**Hudson River Valley Greenway Link**

**Task #5  
Workshop #1 Final Summary**

March 30, 2009

FHRG Comments on the draft GOALS AND OBJECTIVES AND GAP ANALYSIS –  
February 26, 2009

## Legend for the Overview Map

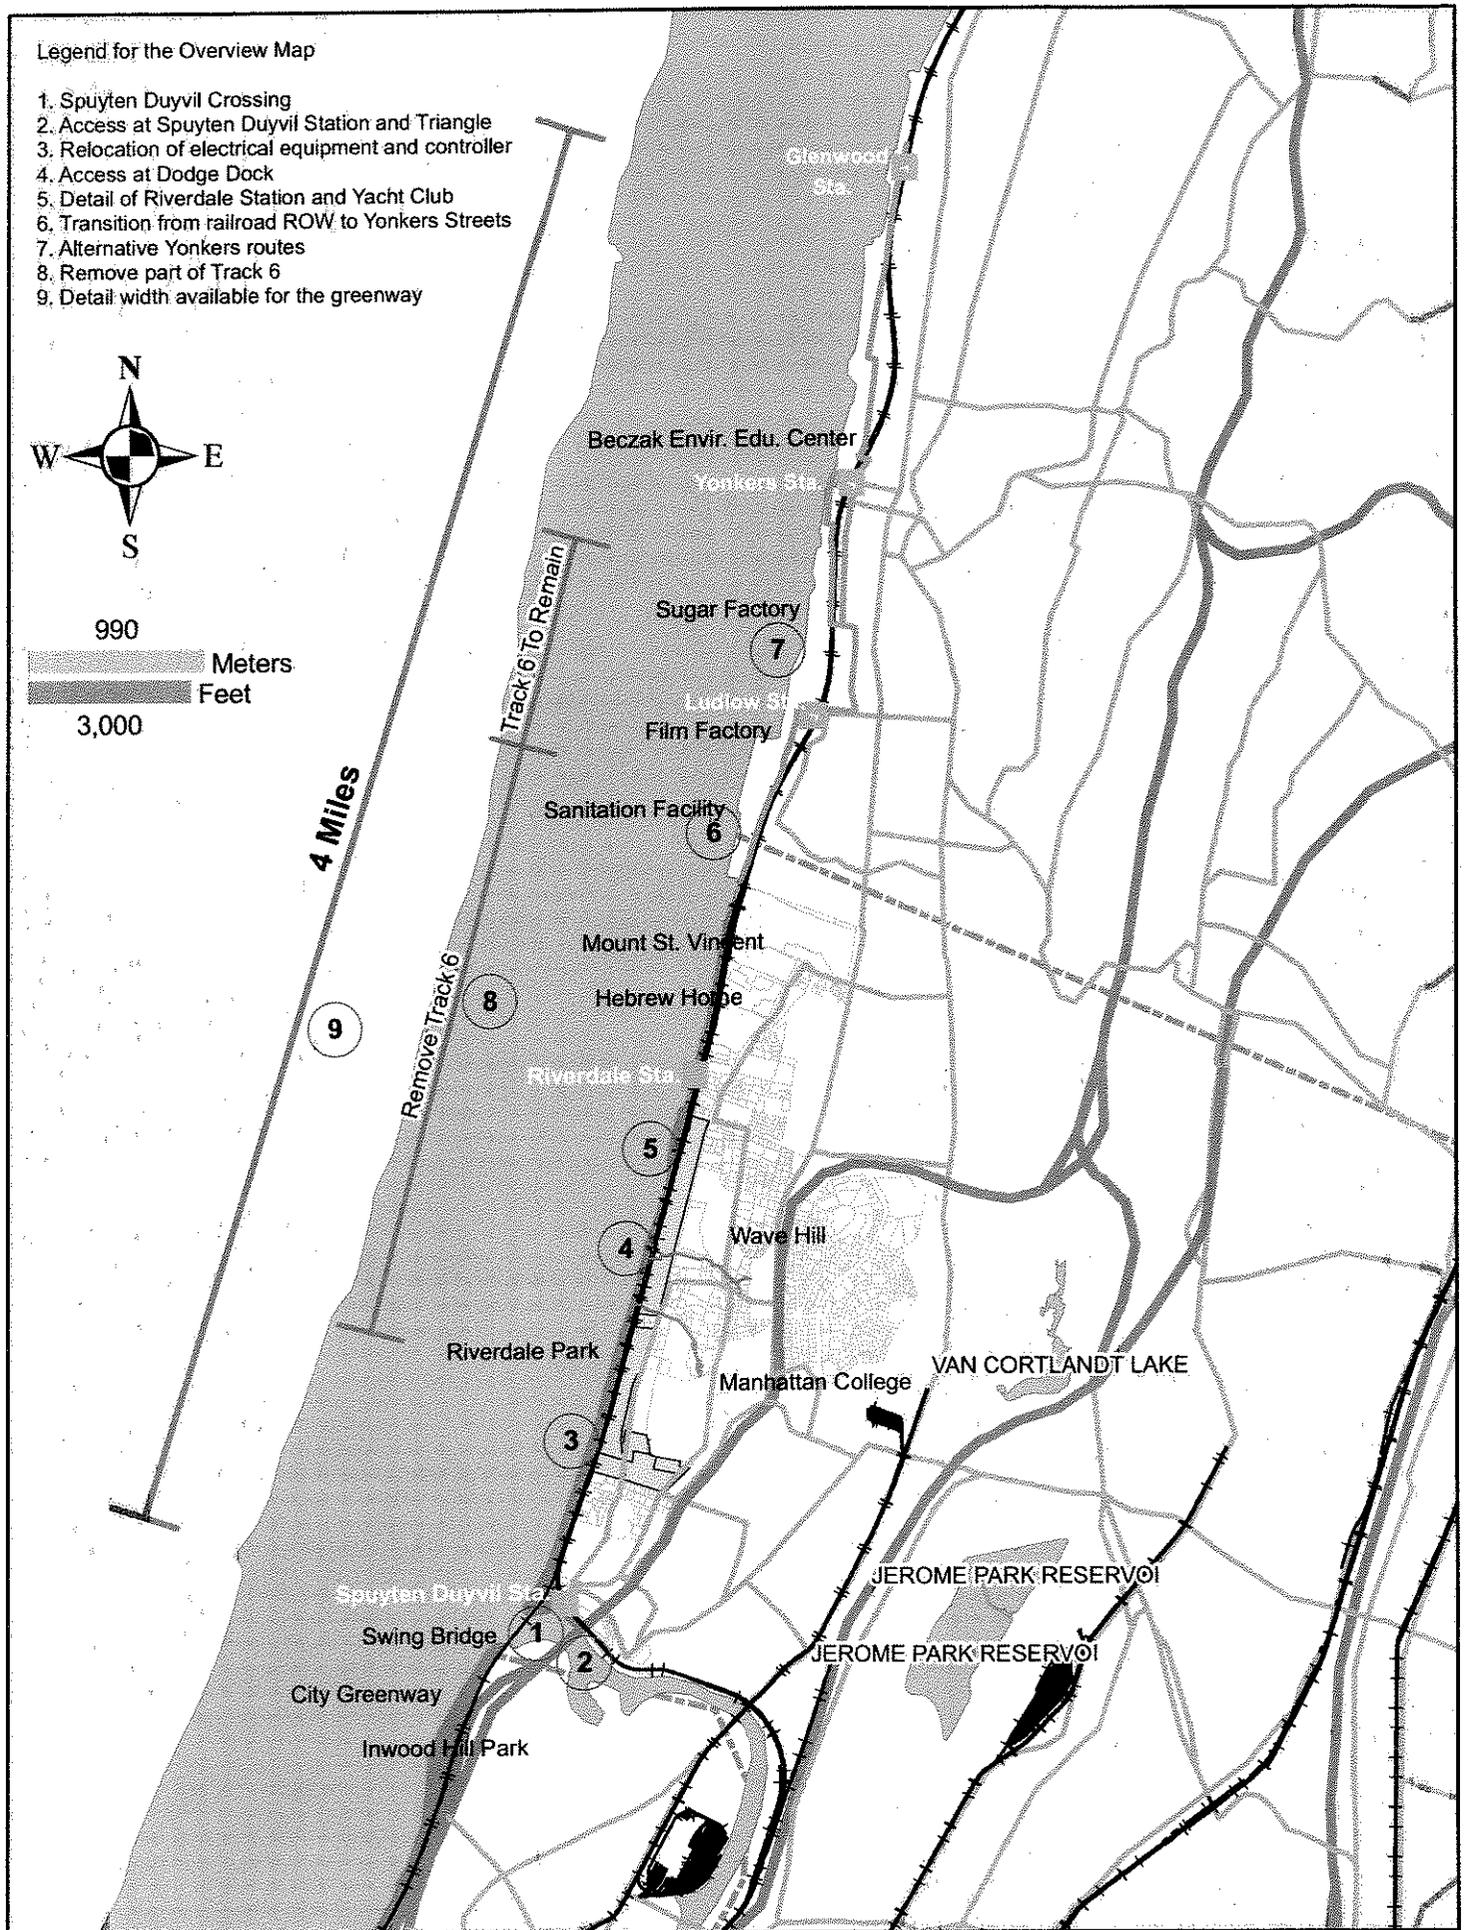
Track 6 - The outcome of the consideration of Track 6 will materially shape the Greenway for a River Alignment. If it is possible to remove part of Track 6, it will provide much more generous space for the Greenway River Alignment. We believe that the switch at the Yonkers' border is sufficient to serve the Sugar Factory and Film Factory in Yonkers. Although we have never seen a long freight train or any other train on Track 6, it may be used for parking disabled trains for the temporary storage of work equipment. The research should address anticipated concerns of the

- a) Riverdale Station and Riverdale Yacht Club – this is one of the squeeze points and we need a detailed plan
  - b) Electrical Equipment – located about 1000 yards north of the Spuyten Duyvil Bridge. What is the cost of moving the equipment to the east side of the tracks?

Prototypical Path  
 along the Hudson River

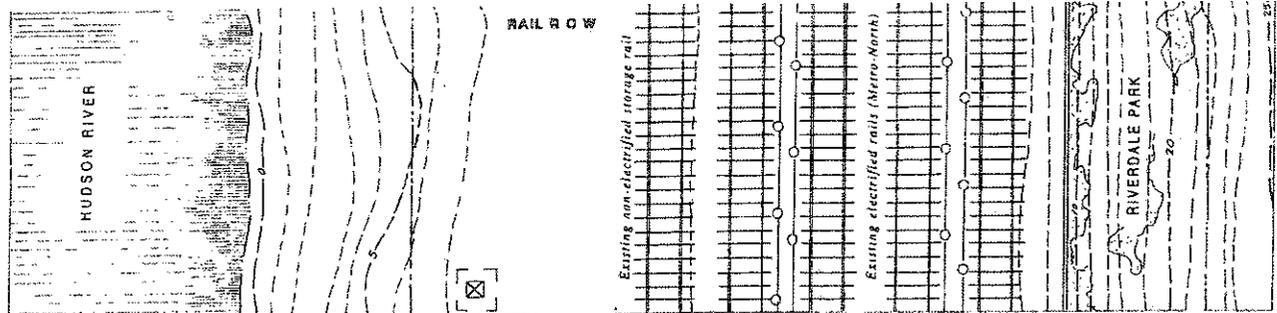
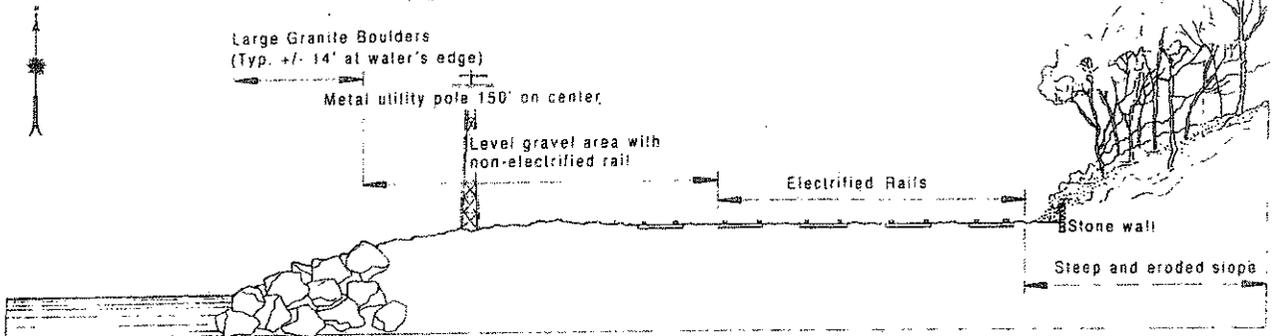
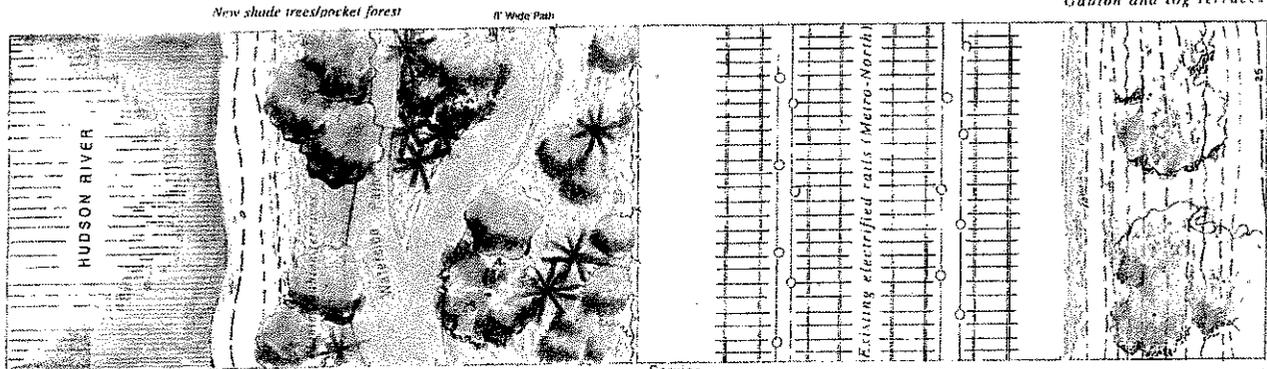
The "high-build" option for a Greenway trail along the shore of the Hudson River could include removing the non-electrified rail and the utility stanchions, improving the shoreline habitat, and providing a trail for public access.

- 1) Width of available space between the required railroad space and the edge of the water at high tide. The requirements of the railroad agencies along the Hudson River will define the River Alignment Alternative. We expect that safety and other requirements of the railroads will shape the proposed Greenway along the waterfront. Fencing, utility road and setback requirements will all define the border and alignment of the greenway. This research should identify the allocation along the alignment that will require building over the rip rap in order to meet the minimum requirements of a walking and biking path.

The Report by the Hudson River Valley Greenway Trail, Bronx Advisory Committee indicated that with Track 6 in place, the pedestrian and bike Greenway could be built partially on top of the existing riprap along the River's edge. However, if Track 6 is partially removed, space for the trail and landscaping would increase significantly. According to the 1998 report, with Track 6 partially removed, the distance from the railroad safety fence to the riprap would vary from 9 to 124 feet. The park agencies of New York City and Westchester/Yonkers should set standards for the Greenway design, including the minimum width required for a pedestrian and bike trail. The evaluation should identify the extent that the space available between the safety fence that separates the railroad operation and the Greenway is greater than this minimum standard and the extent that the space is not adequate and requires a path that is partially built on the riprap.
